LOCAL HISTORIC DISTRICT: Wilmore

PROPERTY ADDRESS: 1827 Wilmore Drive

SUMMARY OF REQUEST: Front porch columns, front walkway changes, rear addition (deck), parking

HDC-2018-00436

Rear Deck Area Current

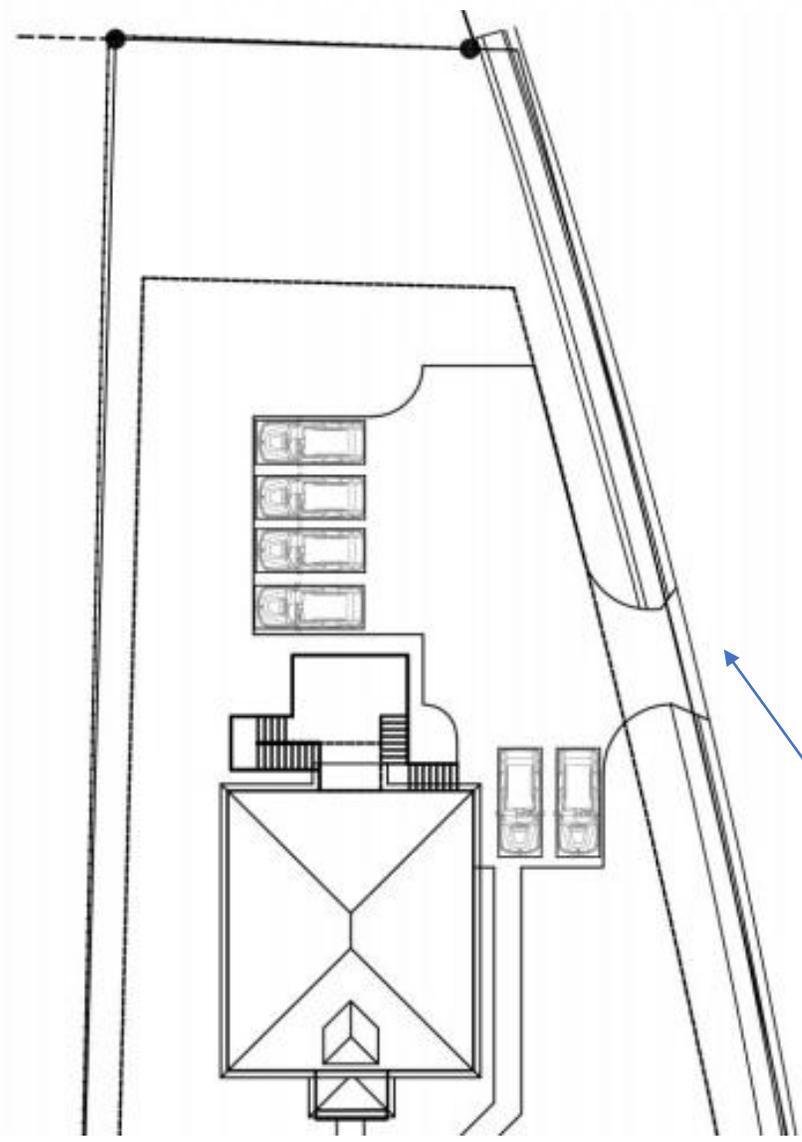
Current porch is deteriorated and lacks proper safety support

Rear Parking Proposed

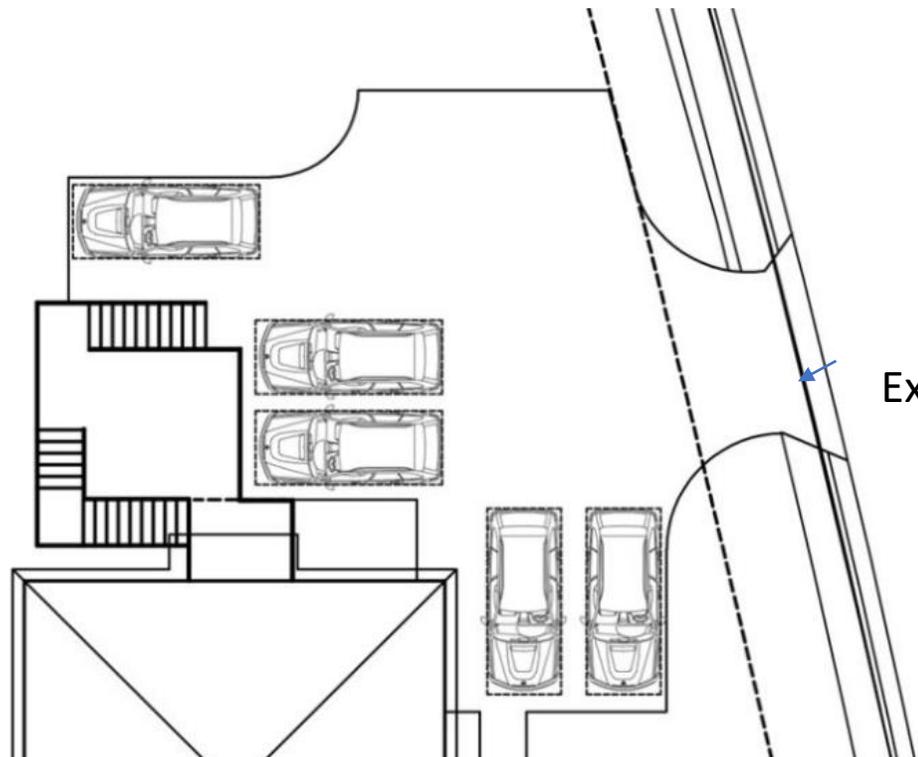
If a driveway apron is existing, and they are now just wanting to attach to it from the private side, it should be compliant, correct? Snip attached.

As long as they don't remove the driveway apron. If they remove the existing apron, they will need to rebuild to new City standards, and that includes the sidewalk to ADA standards as well.
